Item No:	Classification:	Date:	Meeting Name:
	Open	28 April 2015	Sub Committee B
Report title:		Addendum Late observations, consultation responses, and further information.	
Ward(s) or groups affected:			
From:		Head of Development Management

3.1 **Item 1 – Application 14/AP/4715 for: Council's Own Development - Reg. 3 KEYWORTH PRIMARY SCHOOL, FAUNCE STREET, LONDON, SE17 3TR**

3.12 Item 4 – Application 14/AP/4337 for: Full Planning Permission THE CLIPPER, 562 ROTHERHITHE STREET, LONDON, SE16 5EX

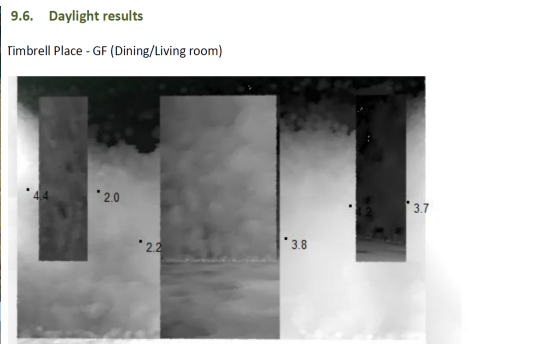
From comparing Timbrell place with the 3D model used by Syntegra consulting to calculate the sunlight and daylight into neighbouring properties. It is clear that Syntegra's 3D model of Timbrell place is inaccurate. This would cause the findings of the tests based on the model to be inaccurate.

The existing windows have large frames which subdivide the glazing into small squares. Syntegra has included the frame area as glazing, instead of modelling the smaller square panels of glazing which exists on site. This obviously allows more light into the rooms so would have an effect on the ADF calculations, the results of which would be more favourable to the applicant.

When Syntegra's model is compared to the existing building, it is clear the shape and size of the windows are different, the photos below show examples of this. The windows marked S5, S6, S7 and S8 on the centre left are modelled as larger than the existing windows. The ground floor window marked S5 centre right has been modelled with a glazed door though the existing is just a window. I have mentioned a number of examples, but further detailed comparison needs to be carried out.

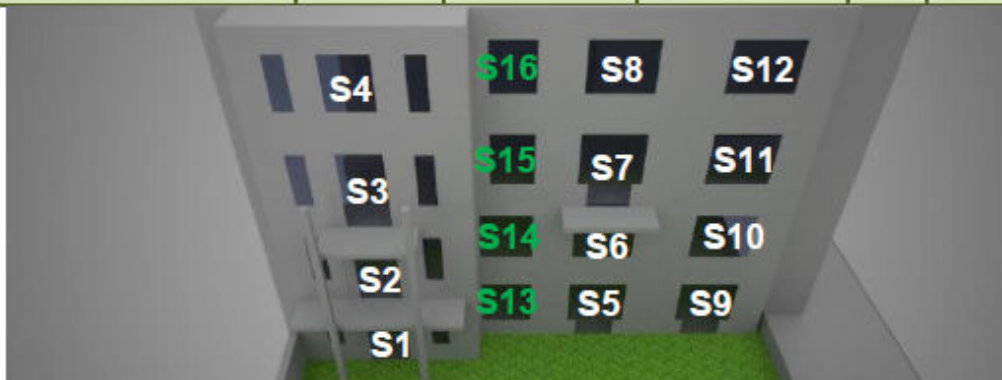
As can be seen in the above table, the following rooms will be impacted by the proposed scheme:

- Ground floor: S1-S13-S5-S9
- First floor: S2-S14-S6-S10
- Second floor: S15 (It should be noted that this impact is only minor and the ratio is falling short of 0.01% i.e 0.79% instead of 0.80% in order to meet the BRE criteria)

However, as mentioned in our first complimentary report, the reduction in the VSC to less than 80% does not necessarily mean the room will be poorly lit. ADF is much more representative of the actual illuminance that the occupants will experience.

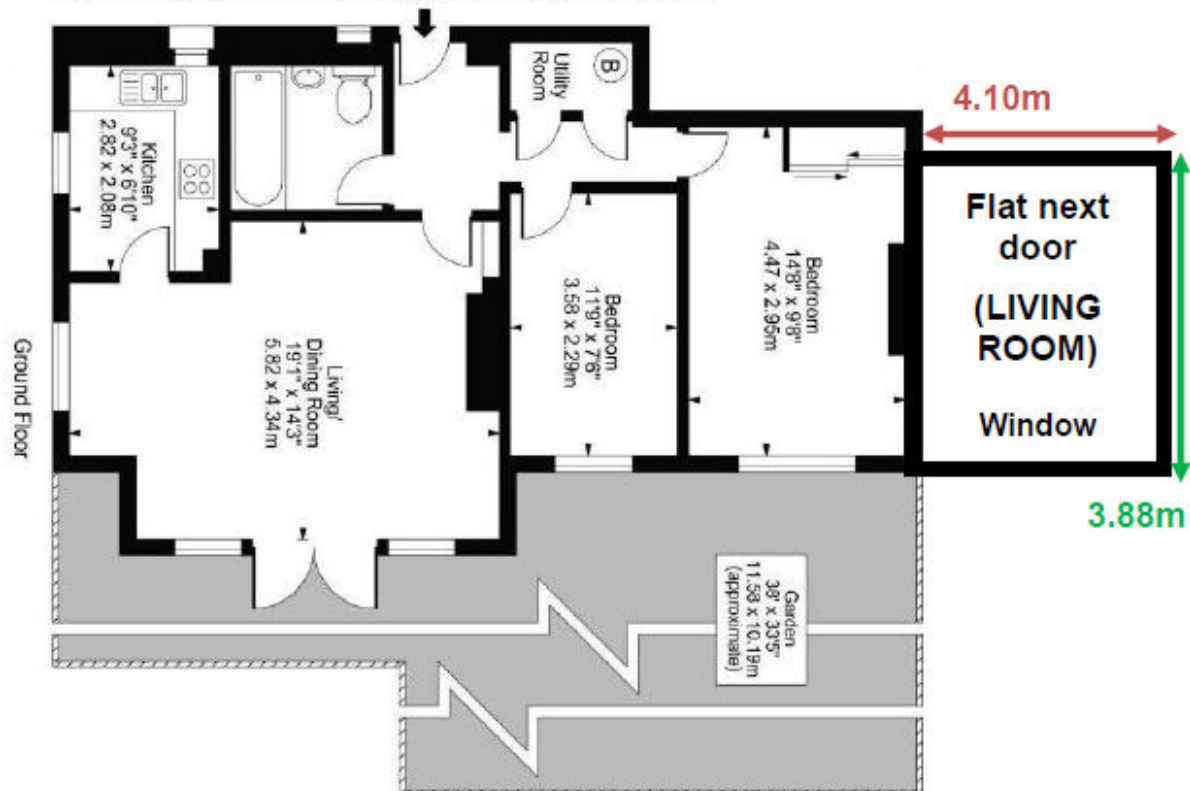
A typical internal layout was used for Timbrell Place as shown below to establish the window positions and room layouts. No floor plans were obtained for the room next door, however, we have assumed the following dimensions based on the size of the building.
